B. Case study 2: A Detailed Design Stage Audit of the Reconstruction of a 300-km Section of a National Highway

Table 9: Case Study 2–Findings of a Detailed Design Stage Audit of the Reconstruction of a 300-km Section of a National Highway

An intersection on a recently rehabilitated section of A-27, 25 km north of the start of the proposed works.

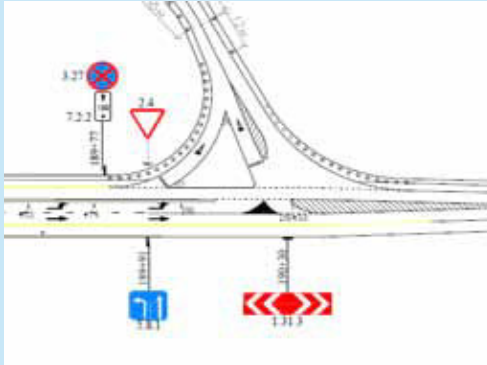
Km	Safety Concern	Risk	Photo	Recommendations	Client Response
Safety Concerns with the Proposed Reconstruction of the National Highway					
General	<p>Throughout the scheme, pedestrian crossings have been proposed to link communities with bus stops. In most locations, these crossings straddle four lanes with no refuge for crossing pedestrians. Users of the crossings will effectively have to cross with no control in a single phase. The presence of the second lane will encourage overtaking in the vicinity of the crossings and potentially higher speeds. These combined factors will increase the risk of conflict between pedestrians and vehicles.</p>	Very high	 <p>Source: TOP Geodezia, Almaty.</p>	<ul style="list-style-type: none"> • Reduce the carriageway from four to two lanes at these locations. • Provide appropriate lengthened entry and exit tapers to negate the need for extra lanes. • Any acceleration lanes for adjacent junctions should terminate in advance of the bus stops, not continue through the bus stop location.
